ALERT SERVICE BULLETIN ASB No. AA-04107 Revision B

SUBJECT: Energy Attenuating Wire
P/Ns 157-13000-39, 157-13000-40, 157-43000-61

MODELS AFFECTED: Bell Helicopter Textron Model 206B with
Energy Attenuating Seat Installations
and Energy Attenuating Wires held as spares.

FIGURE 1 – Parts Identification Label

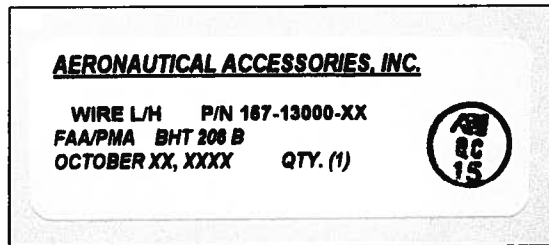
Determine either manufacture date or installation date of subject energy attenuating wires. Date of manufacture is shown on Parts Identification Label (Figure 1).

1. If wires are verified to have been manufactured outside the range of dates shown in table 1, or the date of the applicable Aeronautical Accessories invoice is prior to the dates, proceed to Section I, Step 13. If wire manufacture date is not verifiable or occurred within the range of dates shown, proceed to Section I, Step 1.
2. If wires are verified by written notation in the helicopter's log to have been installed prior to the dates shown in table 1 proceed to Section I, Step 13. If wire installation date is not verifiable or occurred within the range of dates shown, proceed to Section I, Step 1.

**FIGURE 2 – PILOT AND COPILOT
 ENERGY ATTENUATING
 SEAT INSTALLATIONS**

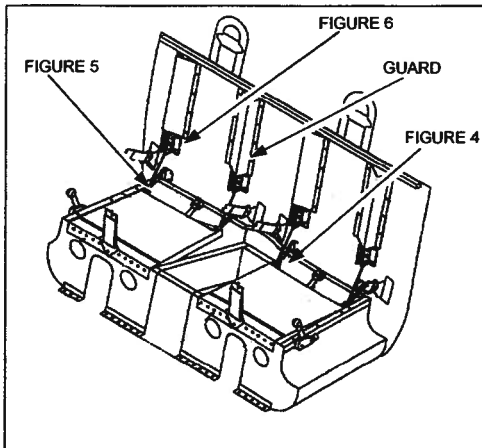
5. Replace rollers (13) and bolts (9) if damage or corrosion is evident, or if rollers do not rotate freely on bolts.
6. Hold center roller (13) in position on new attenuating wire and slide upper end of attenuating wire into guard (Figure 2, 3). Position center roller against bracket (14 or 15) and insert bolt (9) with washers (10 and 11) in middle holes in bracket (14 or 15). Place top roller (13) in position and insert bolt (9) with washers (10 and 11). Place bottom roller (13) in position and insert bolt (9) with washers (10 and 11).

FIGURE 4 – COPILOT AND AFT OBSERVER ENERGY ATTENUATING WIRE SEAT ATTACHMENT

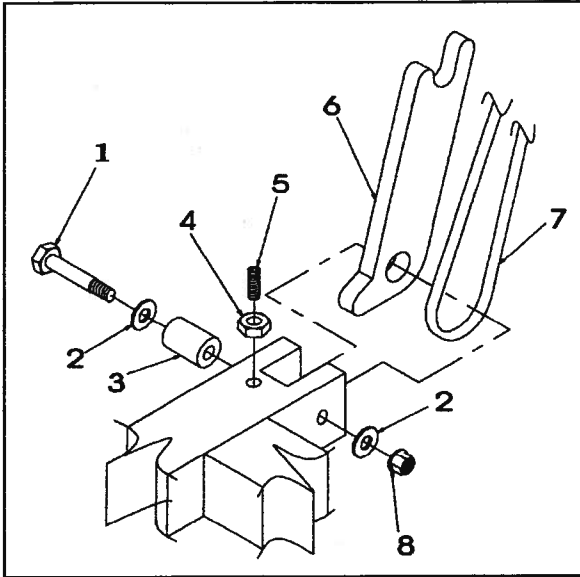
Note: Right side shown. Bolt (1) is always assembled pointing into seat; i.e., left side attachment hardware is opposite to what is shown in Figure 3 for Copilot and aft observer seats. For the Copilot seat, attenuating wire (7) is on the left of the bracket (6) on right and left sides. For the left side of the aft observer seat, attenuating wire (7) is opposite to what is shown in Figure 3.

3. Remove set screw (5) and jam nut (4). Lift seat high enough to clear bolt (1). Remove nut (8), washers (2), spacer (3), and bolt (1). Remove bracket (6).

7. Install remaining washers (10) and nuts (12). Tighten nuts until rollers do not turn, then slightly loosen nuts so that rollers turn freely.
8. Install bracket (6) and align attenuating wire (7) with holes in seat and bracket (6). Install spacer (3), bolt (1), washers (2), and nut (8).

9. Install set screw (5) and jam nut (4). Tighten set screw (5) until set screw makes contact with lever (6). Tighten set screw $\frac{1}{4}$ turn more. Tighten jam nut (4) to 60 – 80 inch-pounds.

FIGURE 5 – PILOT ENERGY ATTENUATING WIRE SEAT ATTACHMENT

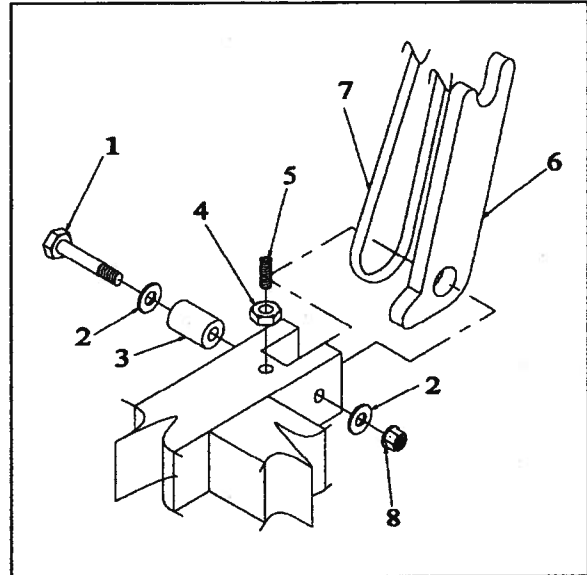
Note: Right side shown. Bolt (1) is always assembled pointing into seat; i.e., left side attachment hardware is opposite to what is shown in Figure 4. Attenuating wire (7) is on the right of the bracket (6) on both sides of the Pilot seat

FIGURE 6 – PILOT AND COPILOT ENERGY ATTENUATING ROLLER BRACKET ASSEMBLY

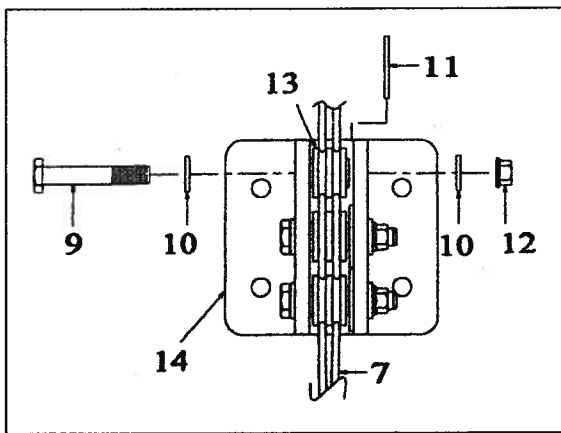
4. Remove bolt (9, reference Figures 6 and 7), washers (10 and 11), and rollers (13) one at a time. Remove attenuating wire (7) from bracket (14 or 15).
